ADMINISTRATIVE SHORT PLAT REPORT & DECISION

REPORT DATE:	August 11, 2015
Project Name:	Dhillon Short Plat
Project Number:	LUA15-000192, SHPL-A
Project Manager:	Clark H. Close, Senior Planner
Owner/Applicant:	Simrit S. Dhillon, 14519 SE 262nd St, Kent, WA 98042
Project Location:	11836 and 11850 SE 191st Street, Renton, WA 98058 (APN's 087500-0090 and -0130)

DHILLON SHORT PLAT

DNW. BY	DATE	JOB REF.
R.G.	7/01/15	DHILLON
CHKD. BY		SHEET
P.K.		1 OF 2

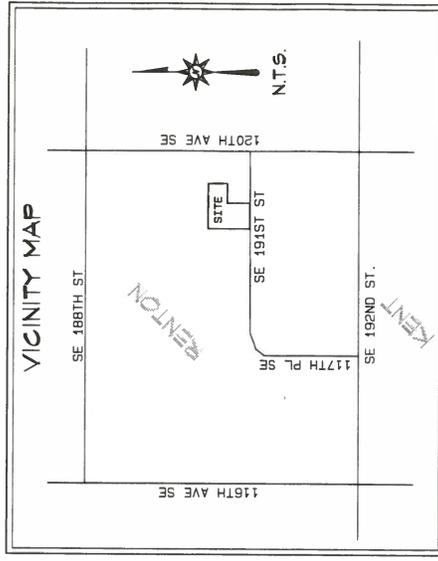
The City of Renton Administrator, Public Works Department, is the only city official who signs the final short plat submittal. Provide an appropriate approval block and signature line (remove the reference to the "DEPARTMENT OF COMMUNITY AND ECONOMIC DEVELOPMENT" and "PLANNING DIRECTOR").

The reference to the "Tax Parcel Number" (upper right hand corner of Sheet 1 of 2) should be smaller in scale.

Note the plat name and lot number(s) for the properties to the north of said short plat site.

All vested owner(s) of the subject final short plat need to sign the final short plat drawing. Rainier Title provided a title report dated March 12, 2015. Under "SCHEDULE A" of said report, it is stated that Lakhbir Singh, together with Simrit Dhillon, is an owner of the subject short plat property. Reference Mr. Singh as an owner under the "OWNERS DECLARATION" block (Sheet 1 of 2) and provide a signature line for him. Another "INDIVIDUAL ACKNOWLEDGEMENT" block is needed for Mr. Singh, or include him in the existing acknowledgement block.
